ELEVATOR PIT SECOND FLOOR PLAN

APPROVER:
PLEASE VERIFY
THE ALL CLOUDED SECTION SIZES,
ELEVATIONS AND DIMENSIONS

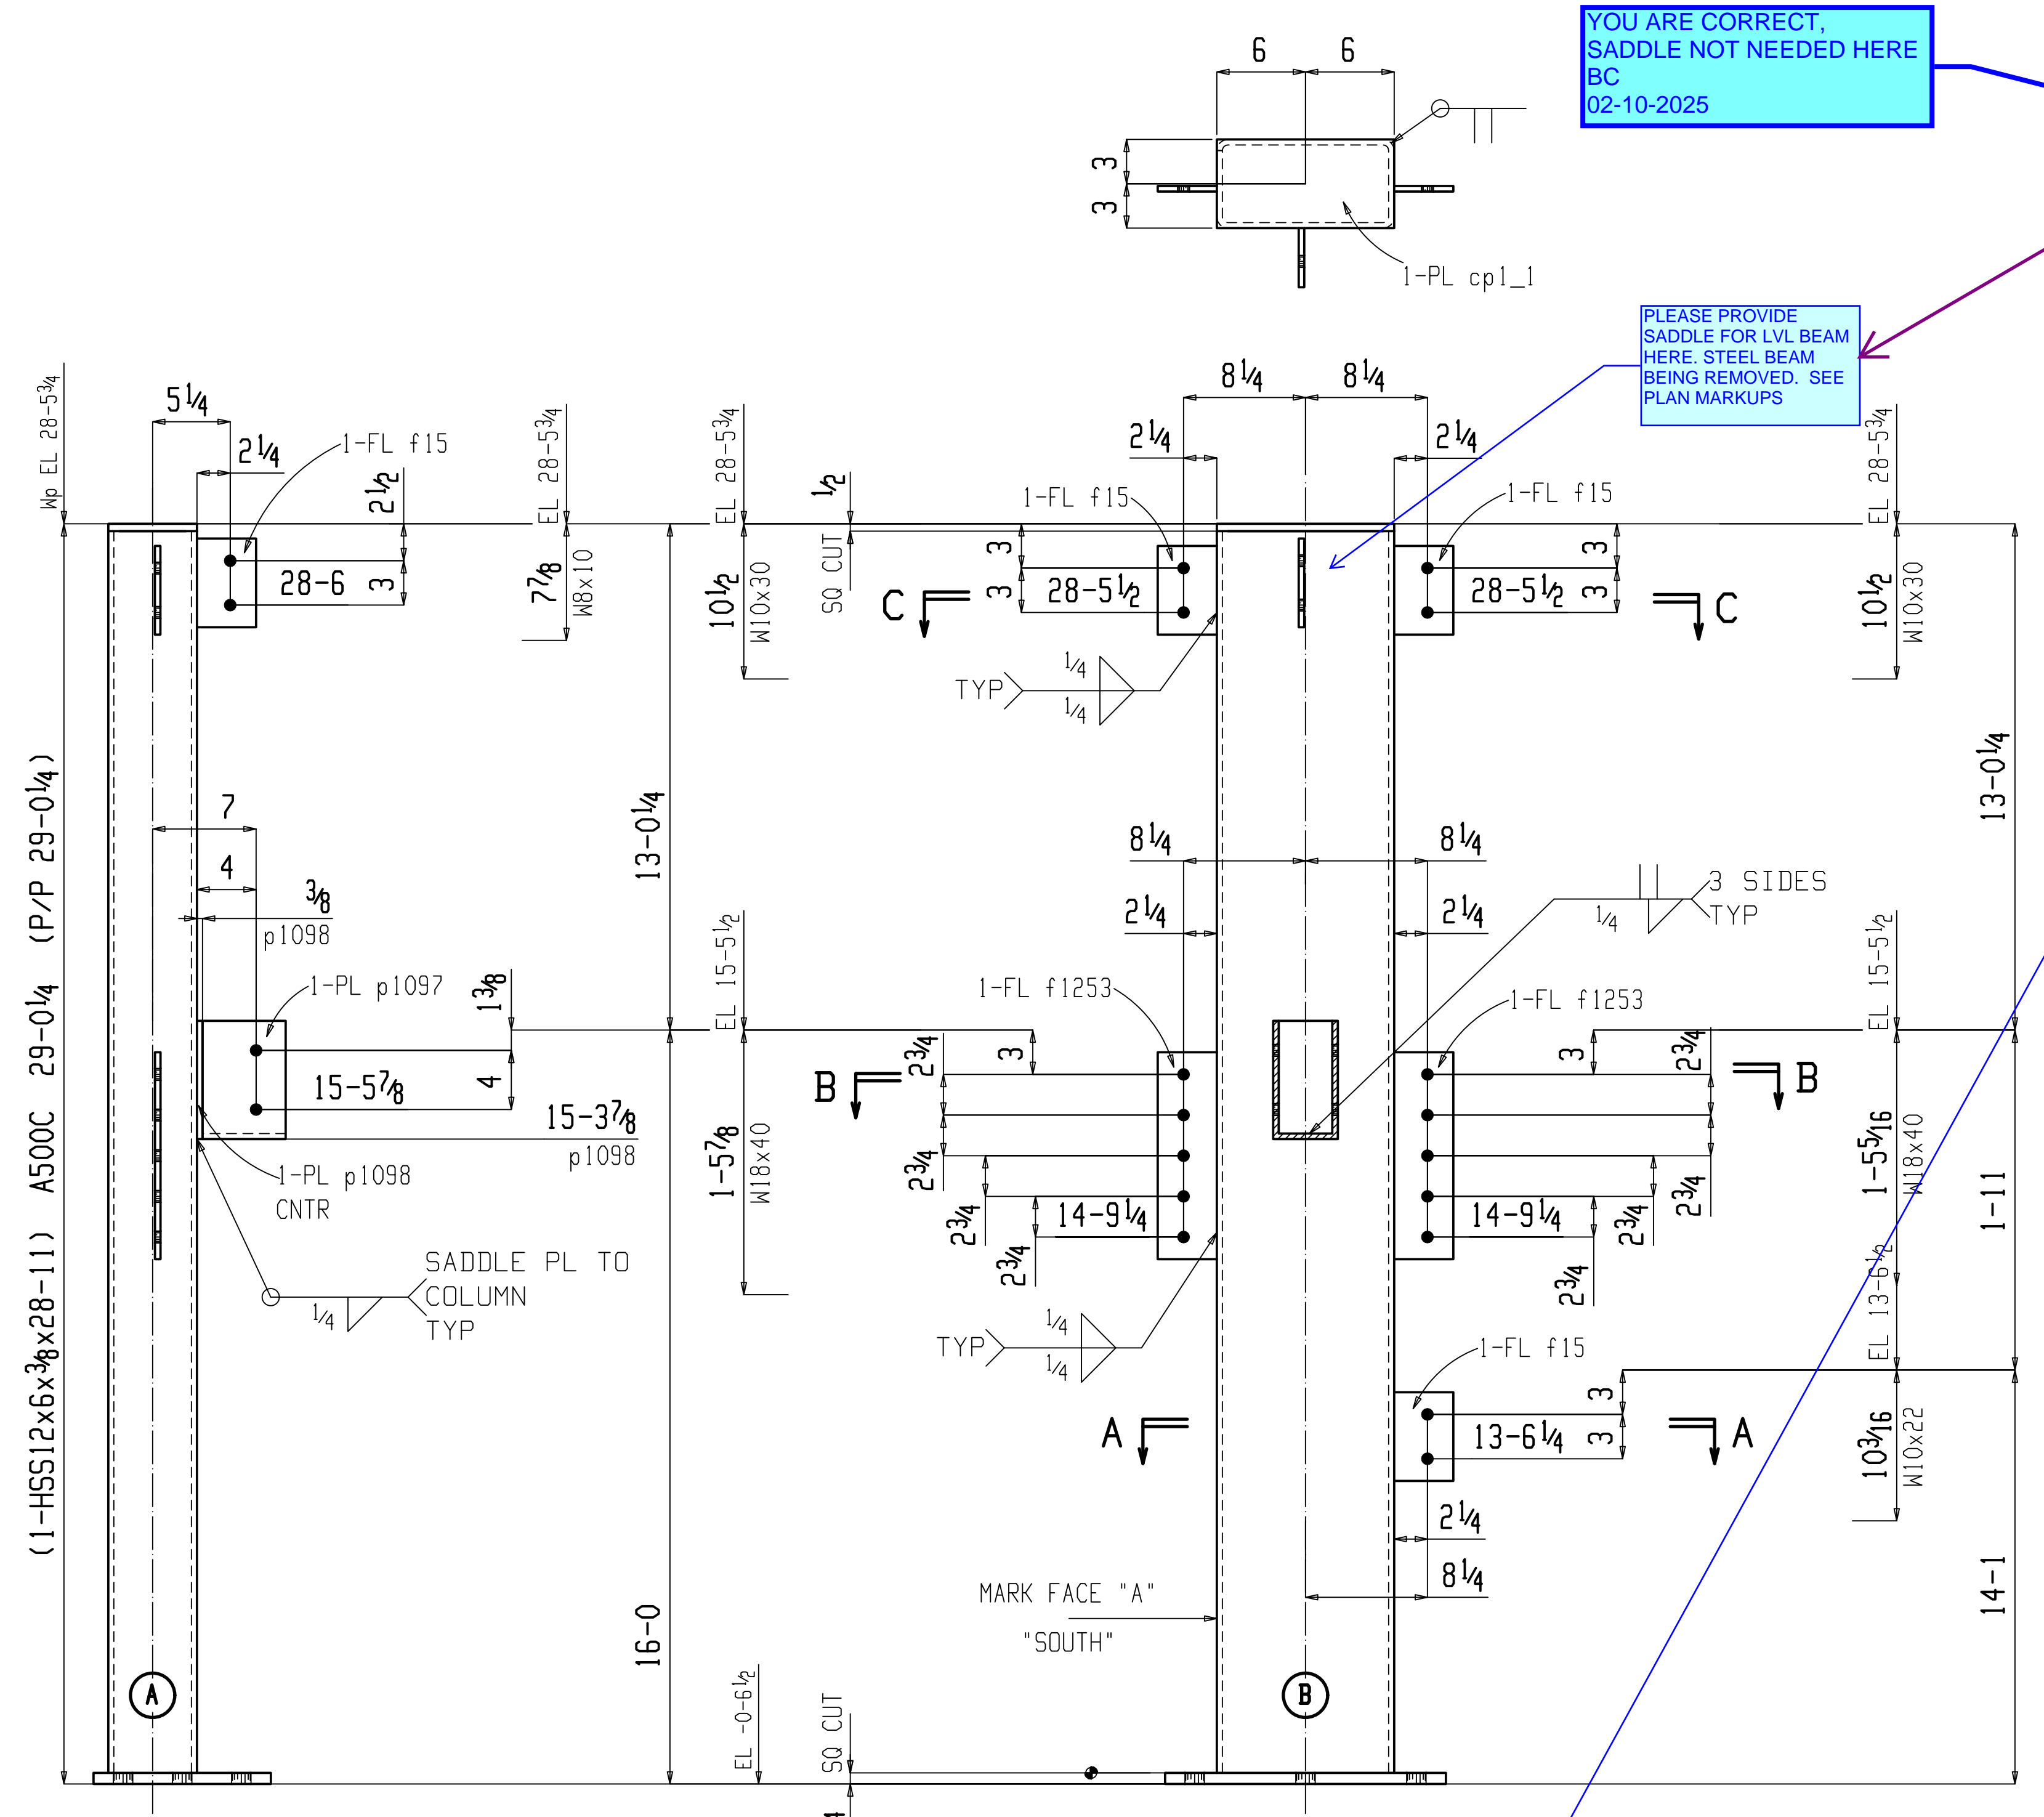
PLEASE PROVIDE SADDLE FOR LVL BEAM HERE. STEEL BEAM BEING REMOVED. SEE PLAN MARKUPS

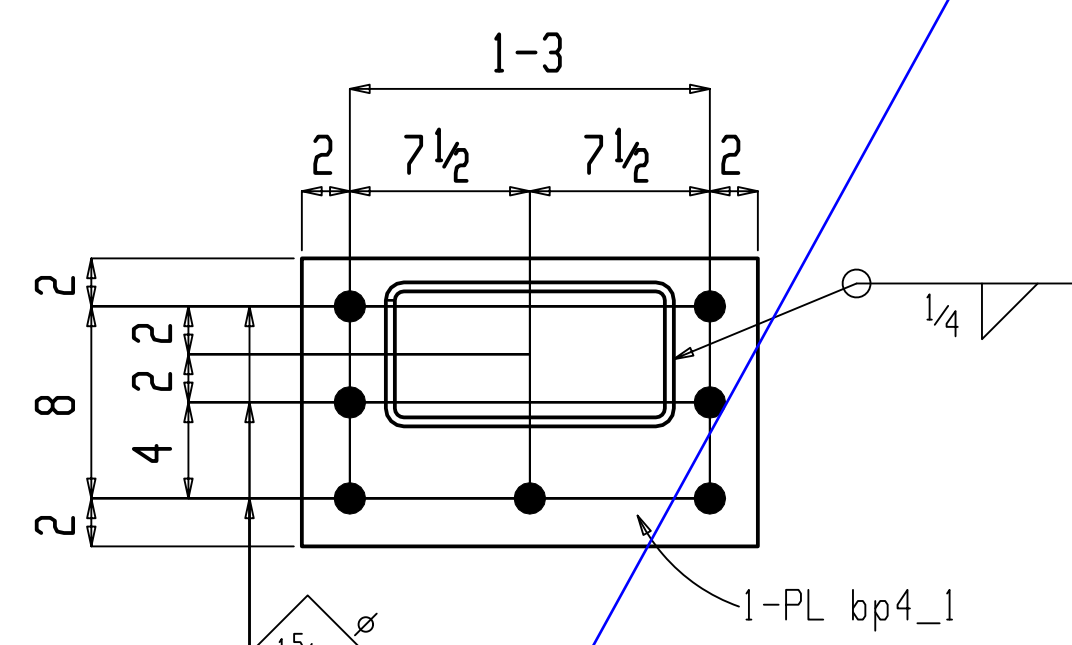
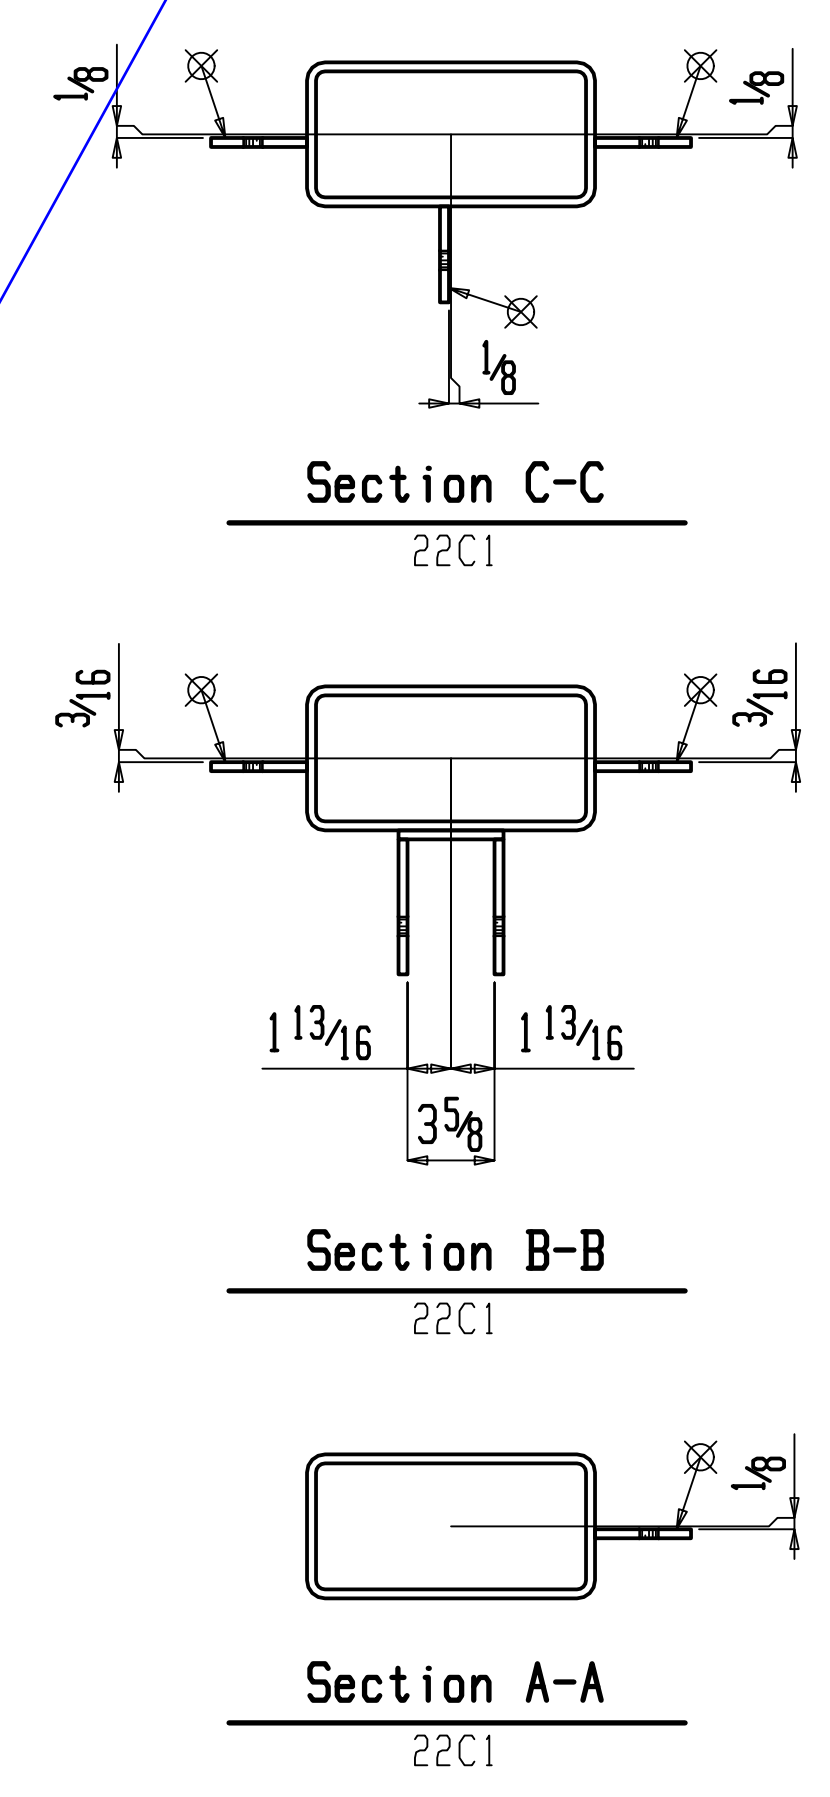
LOOKS LIKE MAYBE THE WRONG COLUMN GOT MAREKD UP REFERRING TO THE MARKUPS ON SHEET E2?
